Fryderyk Chopin University of Music Warsaw, Poland

- Acoustic Design Commentary Phase 1: User Comment Response -

Our reference;
WML/2755 ADC - 1

Acoustic Design Commentary Document- User comment response

RT against Frequency: Room 004

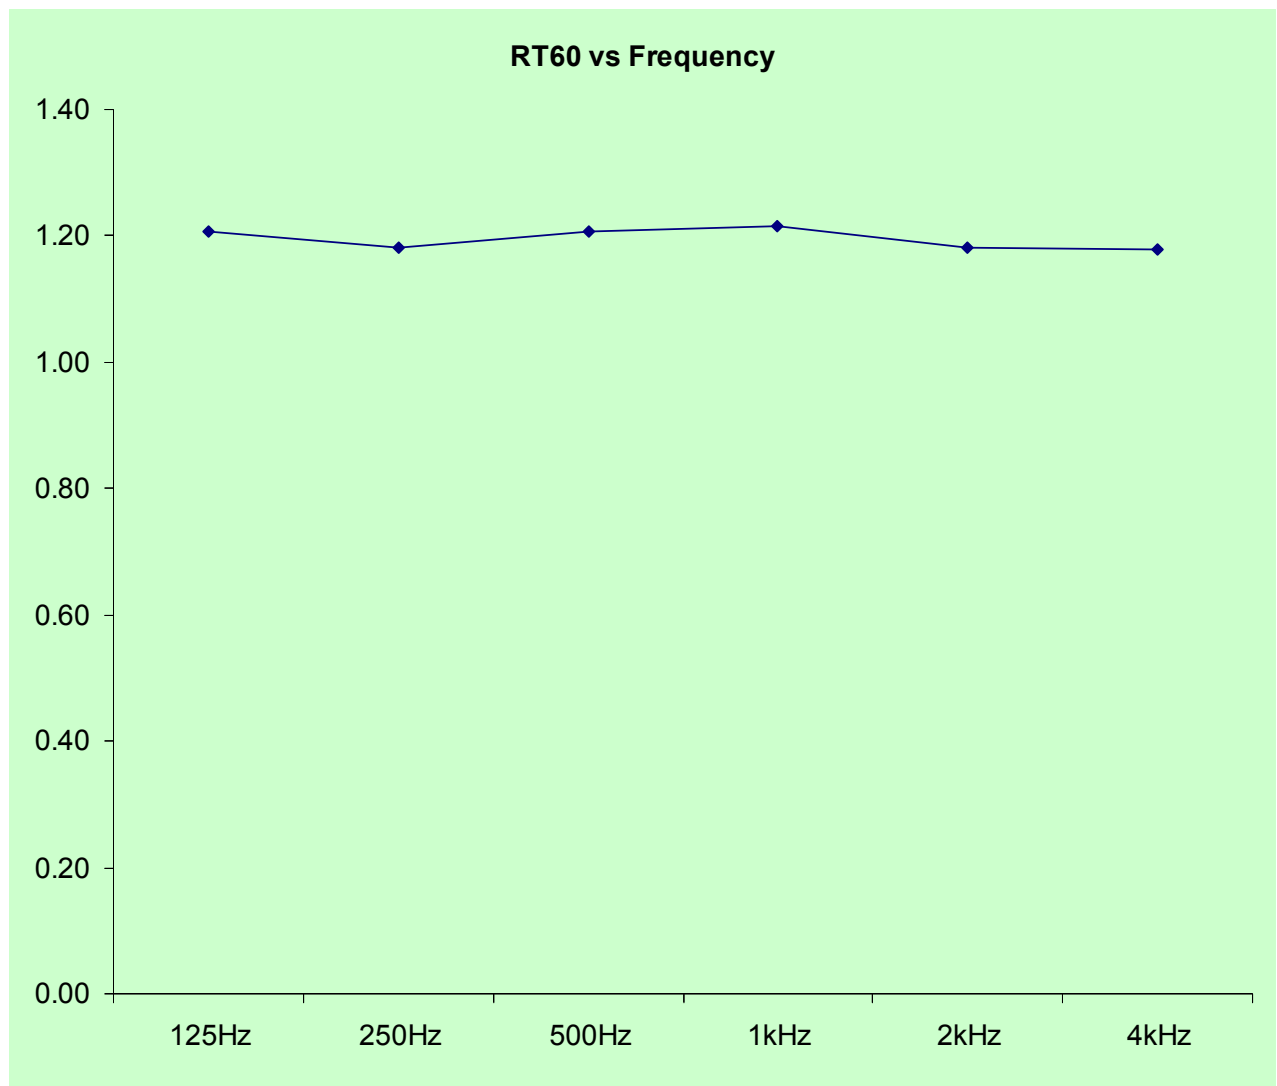
3(a) Tolerances of reverberation time targets

It is the intention of the design in this area to create a reverberation time response against frequency that is accurate to the prediction. Due to modal response issues within any room and the change in the mean free path of any sound as both the source and monitoring positions move within the space, some variation will be noted over the area of the room. Assuming that the edges of the floor area are avoided other than in cases of specific need, the diffuse design characteristics employed should ensure as even a response as possible across the whole room. Individual band tolerances can be expected to be within 10% of the predicted value but it is anticipated that an iterative approach can be taken during installation whereby check measurements can be taken and adjustment of the final acoustic treatment made. This should allow a more accurate response to be tailored but it is noted that this calibration process must be allowed for in the construction programme and budget and the costs of measurement and design refinement be included at that stage.

A revised RT prediction is offered showing the adjusted response requested, both in the room's normal state and after the addition of curtains to render the space suitable for cinema style use. The RT prediction is compared to a Dolby recommendation for a space of such a volume for reference and is shown to offer a response compatible with the monitoring environment in the Dolby ATMOS theatre.

3(b) Isolation calculations for open microphone areas

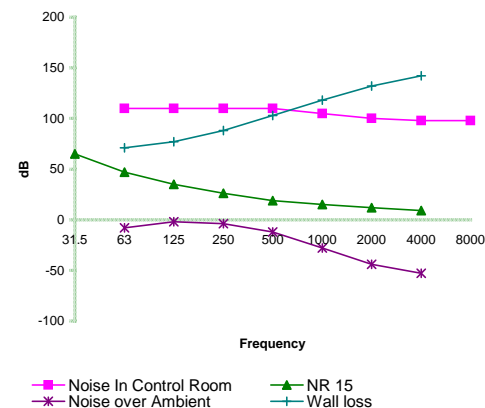
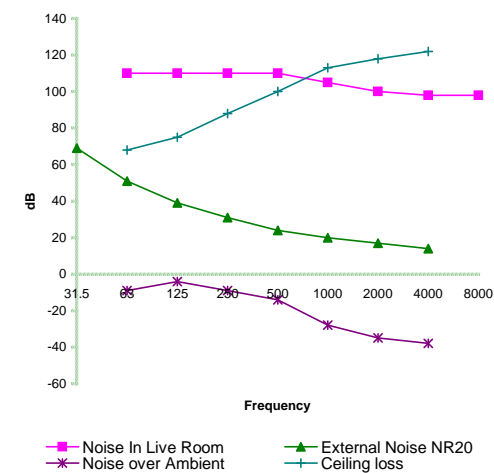
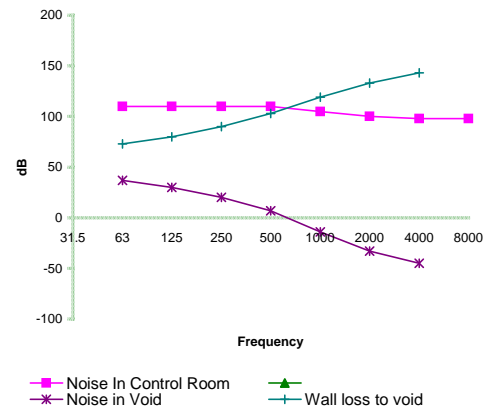
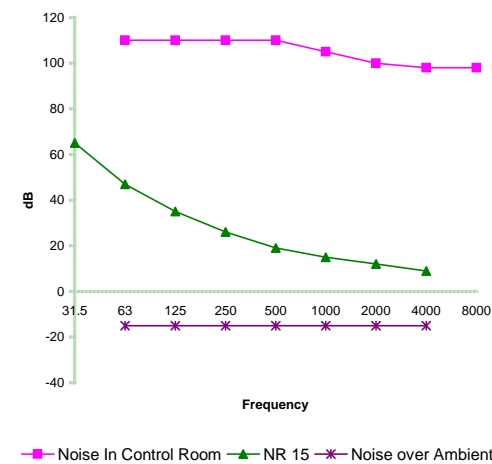
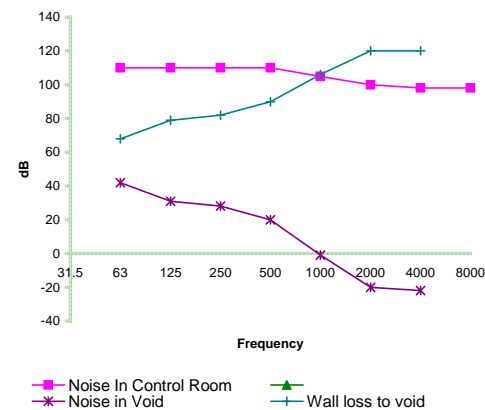
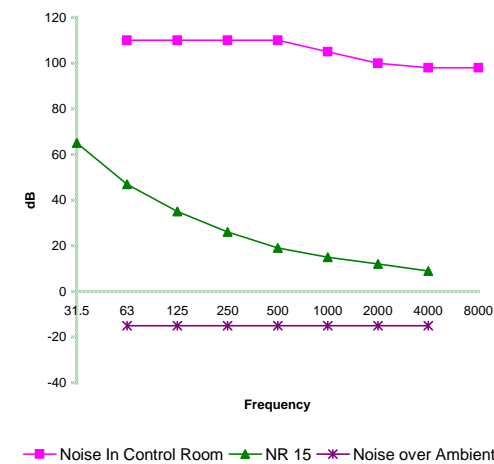
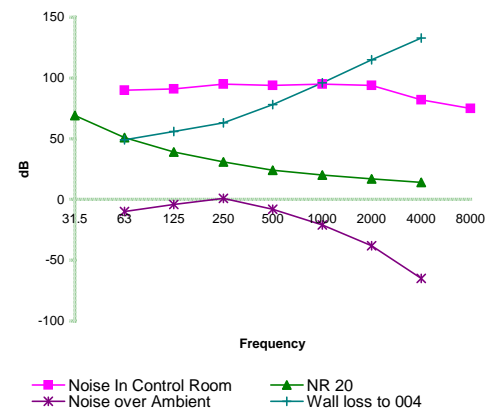
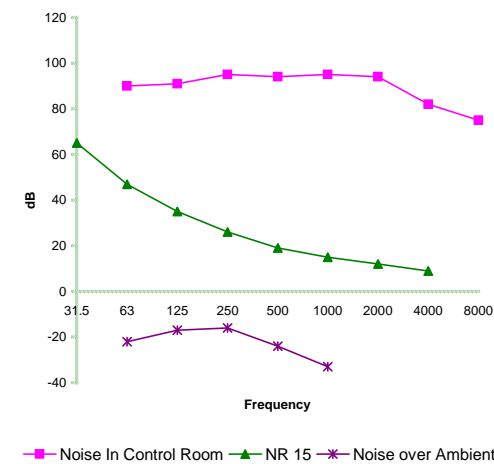
It is noted that the noise floor in all open microphone areas is requested to be set at NC15. The following charts illustrate the previously issued calculations so adjusted.

Note that the operating levels within Room 007 have been set at lower values to reflect the necessary management of room use and also the illustrated need for cavity damping in the isolation walls to achieve the necessary noise floor in Room 004.

3(c) Isolation calculation for Anechoic chamber (Room 009)

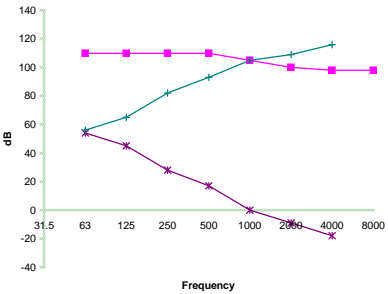
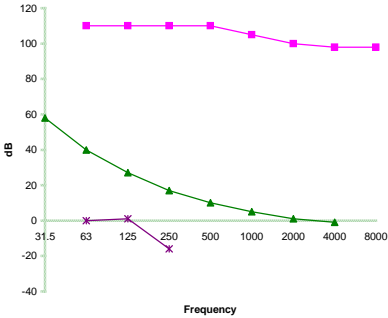
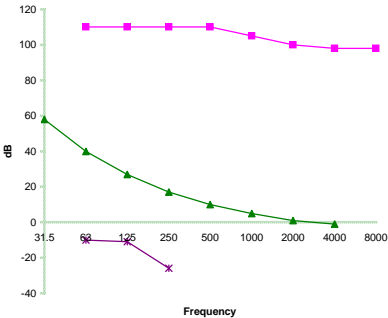
Calculations have been performed for the isolation expected between the new Control Room (Room 004A) and the Anechoic Chamber (Room 009) and are illustrated here. These consider the wall constructions only, as it is unknown whether Room 009 is floated on isolation mounts or has an isolation cap to its inner wall structure.

It can be seen that the highest expected normal running level in the Control Room comes close to causing disturbance in the Anechoic Chamber when the isolation is assessed on the basis that the cavity is un-damped and NR05 is adopted as the target noise floor. The improvement in the performance with a damping fill of 75mm RW3 mineral wool is also illustrated and it would be strongly recommended that this is installed during construction, as is also the case in the cavity of the isolation walls of Room 007.
